- 3. Enzler Subdivision 2026 Replat; KPB File 2026-003
McLane Consulting Group / Norris
Location: Big Eddy Road, Joplin Circle & Enzler Place
Ridgeway Area**

**ITEM #3 - PRELIMINARY PLAT
ENZLER SUBDIVISION 2026 REPLAT**

KPB File No.	2026-003
Plat Committee Meeting:	February 9, 2026
Applicant / Owner:	Dustin Norris / Kenai, AK
Surveyor:	Andrew Hamilton/ McLane Consulting Inc. Soldotna, AK
General Location:	Big Eddy Rd

STAFF REPORT

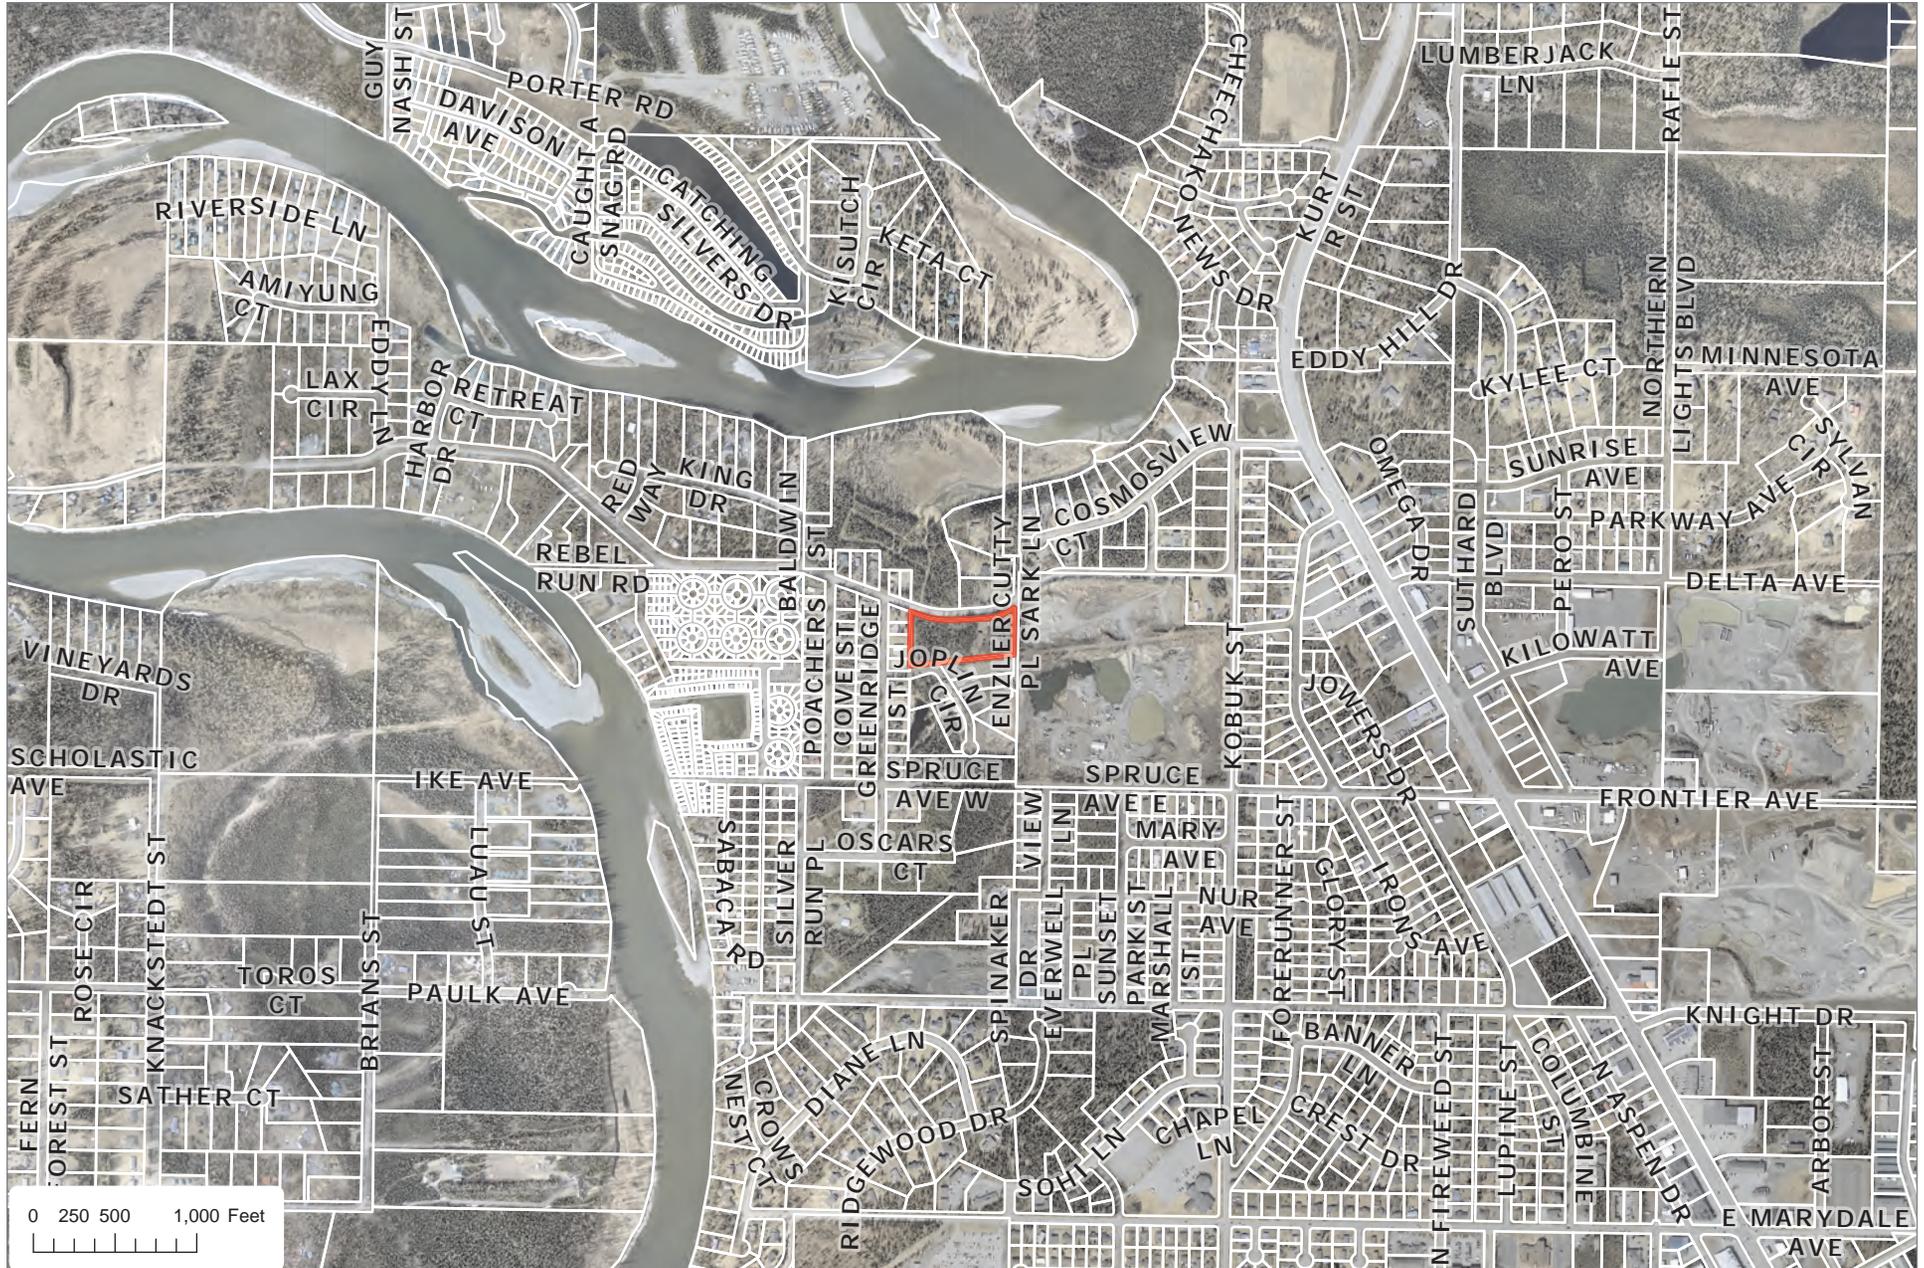
According to SOA DOT&PF Review: no direct access to Big Eddy Road will be allowed for the proposed lots. Proposed Lot 1, Block 1 must take access from Joplin Circle and Lot 2, Block 1, must take access from Enzler Place. **Staff recommends** corresponding plat notes be placed on the final plat indicating the allowable access for each lot.

Wetlands to do not affect the property. The parent plat does indicate a line of flooding from ice jams in Kenai River (U.S. Army Corps of Engineers, 1967). **Staff recommends** the surveyor verify any issues related to this statement for this property have been mediated and report finds to staff of results and show on drawing if needed.

The 30’ Alaska Pipeline Easement shown on plat K-1762 should add the parent document of book 5 page 159 to the notation on the drawing.

Add to the plat notes reference to items 9 & 10 of the CTP

- Acceptance of this plat by the Borough does not indicate acceptance of any encroachments.

Add the KPB File No of 2026-003 to the drawing.

Enzler Place on the east, is currently a 25' dedication, the land to the east is in process of being developed and dedicating 25' ROW and bulb, check with staff before final is submitted to check status. Changes 50' to 25 to be current.

Big Eddy Rd should be shown correctly on vicinity map

Lot to the north needs revised to Lot 4

Tract to the east is n process of being subdivided, prior to final submittals, surveyor should check with staff on status of land to east.
